STATE OF WASHINGTON
DEPARTMENT OF ECOLOGY

October 2, 2008

Re: Opinion on Proposed Cleanup of the following Site:

- **Site Name:** City of Tacoma 35th Street Landfill
- **Site Address:** 35th Street and Pacific Avenue, Tacoma
- **Facility/Site No.:** 5774537
- **VCP Project No.:** SW0938

**Current and Historical
Sampling Locations**

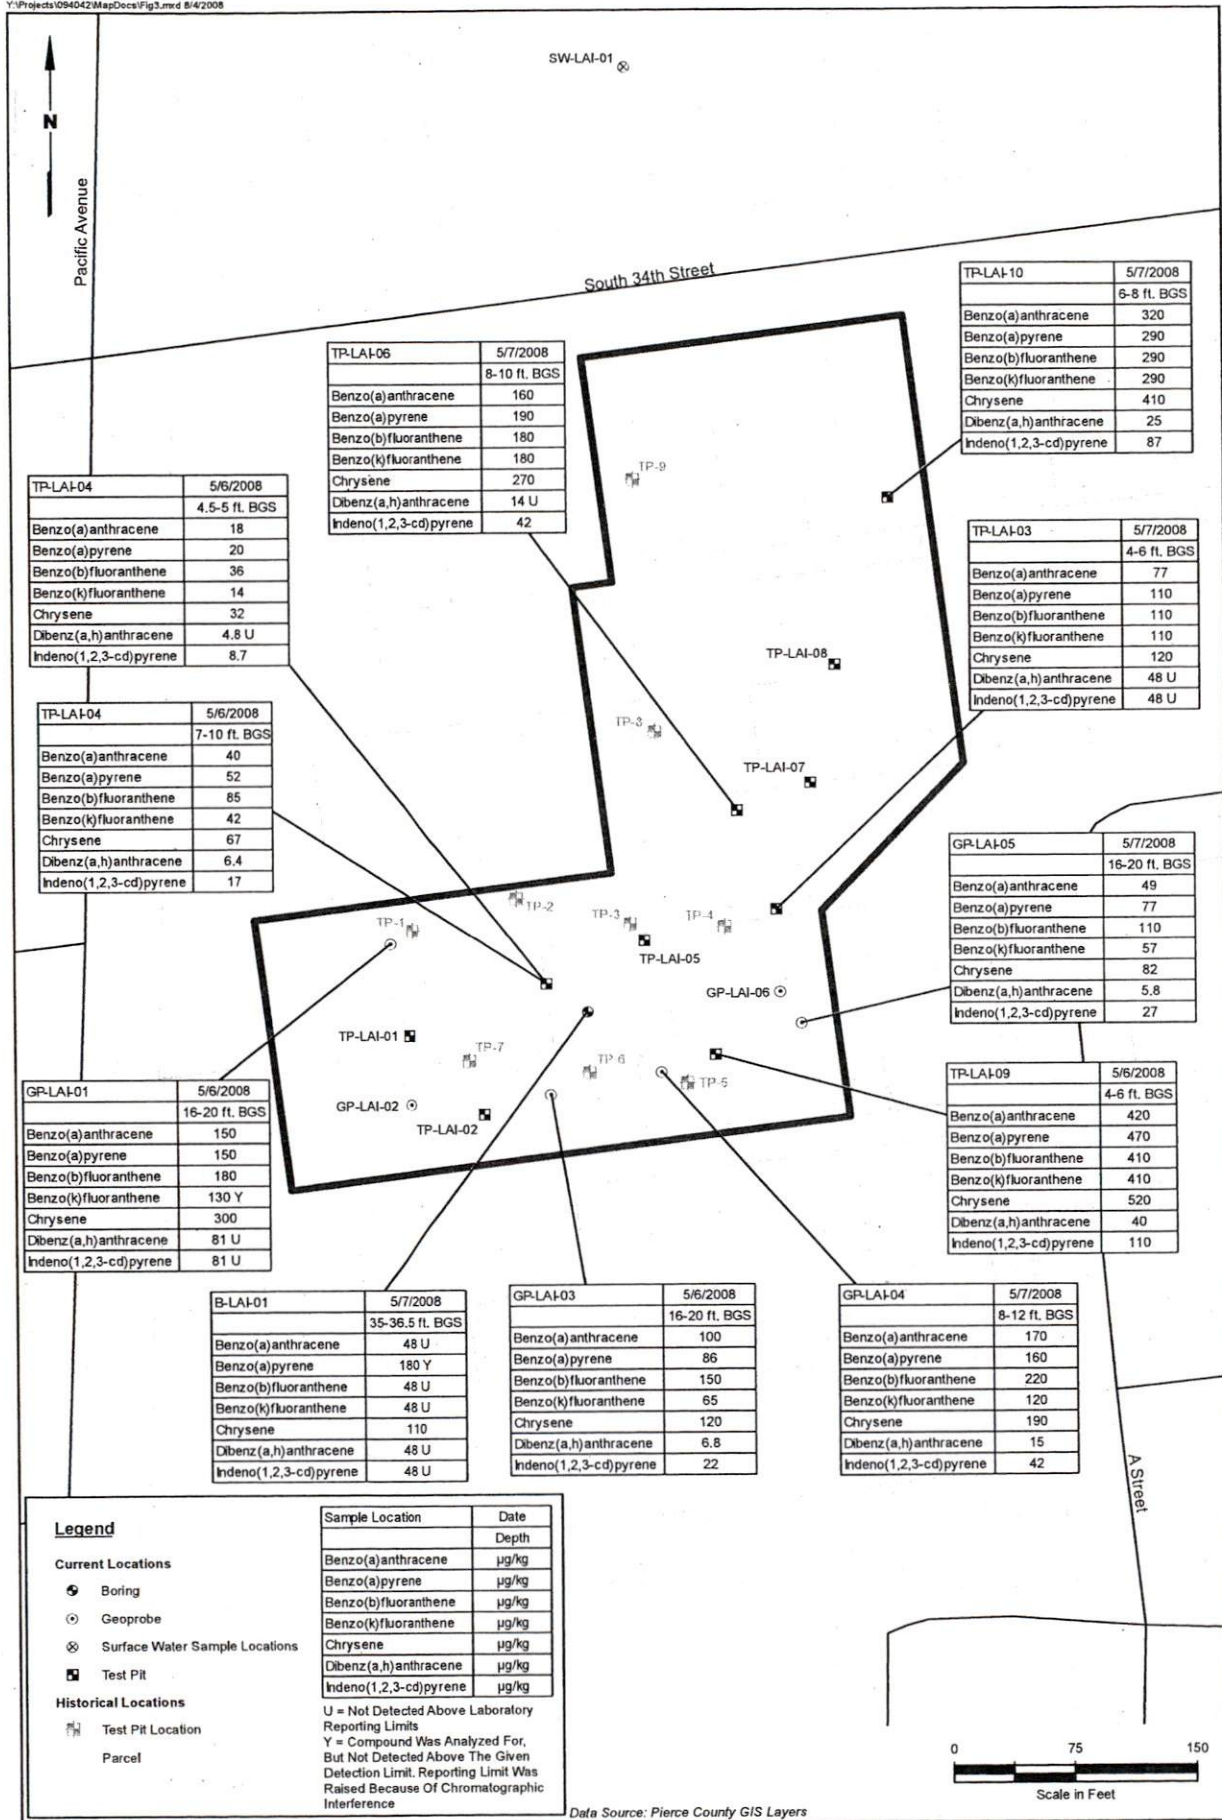
- **cPAHs** – cPAHs were analyzed at 11 locations where soil was estimated to have the highest potential for cPAH impact. Concentrations, adjusted to Toxicity Equivalency Factors (TEFs), exceeding the MTCA Method A soil cleanup level of 0.1 mg/kg were observed at eight locations with total cPAH concentrations ranging from 0.103 to 0.614 mg/kg at depths ranging from 4 to 20 ft bgs.

- **cPAHs** – cPAHs were analyzed at 11 locations where soil was estimated to have the highest potential for cPAH impact. Concentrations, adjusted to Toxicity Equivalency Factors (TEFs), exceeding the MTCA Method A soil cleanup level of 0.1 mg/kg were observed at eight locations with total cPAH concentrations ranging from 0.103 to 0.614 mg/kg at depths ranging from 4 to 20 ft bgs.

Recommended in-situ containment activities consist of placing and maintaining a soil and vegetative soil cover over areas across the site where cPAHs exceed MTCA cleanup standards in the upper 15 ft bgs. Currently it appears that cPAHs may be present throughout the site. However, additional sampling should be conducted to determine more precisely the cPAH distribution and delineate areas where capping is necessary. Sampling should be

completed on a regular grid pattern with samples collected from two depths between 0 and 15 ft bgs in each grid. Vegetation should be removed and composted in areas where containment is necessary. A 1½ ft thick soil layer consisting of clean soil or structural fill and a vegetative surface layer should be placed over the fill. This cap should be placed in areas where cPAHs exceed cleanup levels but not in areas occupied by buildings or paved surfaces, or in areas where cPAHs do not exceed cleanup levels.
